# SERVICE BULLETIN

## CRACKS, WEAR AND DISTORTION ON THE CARBURETOR FLANGE ON ROTAX<sup>®</sup> ENGINES TYPE 912 AND 914 (SERIES)

**SB-912-030**

**SB-914-019**

Bild / Fig. 1

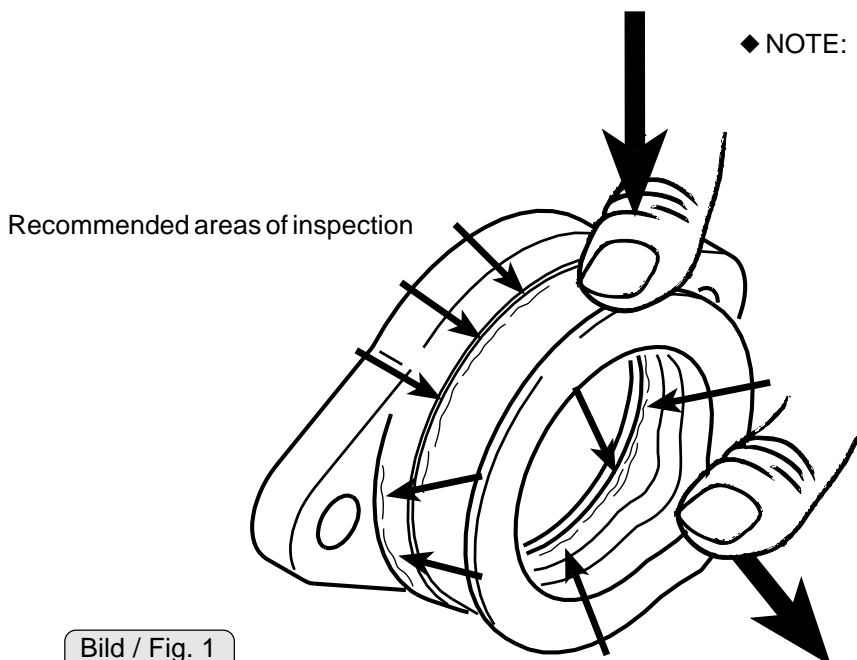
Inspection of the carburetor flanges in accordance with the relevant Maintenance Manual and the information contained in Section 4) Appendix, Figure 1 .

- Within the next 10 hours of operation the carburetor flanges must be inspected for damage, cracks, wear and distortion according to the following instructions in section 3. Replace as required.
- Every 50 hours of operation the carburetor flanges must be inspected for damage, cracks, wear and distortion according to the following instructions in section 3. Replace as required.
